Addendum 2

HVAC Upgrades for BWHS, JLHS, and Arends Center

ADDENDUM NO: 02
 PROJECT NAME: HVAC Upgrades for BWHS, LJHS & AAC
 PROJECT ADDRESS: Bentonville & Centerton AR
 PROJECT NO: 2549

Item No. 1: **Refer to Architectural Sheet A1.1, detail A7.**

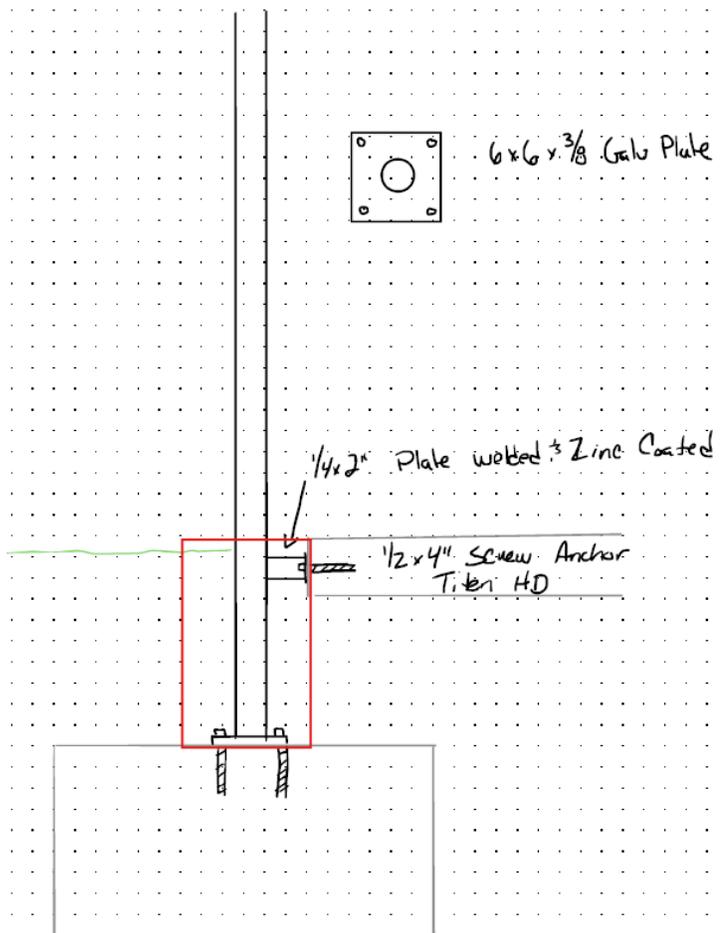
1. In lieu of coring through existing footing chain link fence installer is allowed to modify connection by providing base plate attachment to the top of the existing footing and angle attachment to the vertical edge of existing concrete slab. Specific attachment design is the responsibility of the installer to ensure a sound installation. See attached sketch for possible connection. Connection is required to both footing and slab edge.
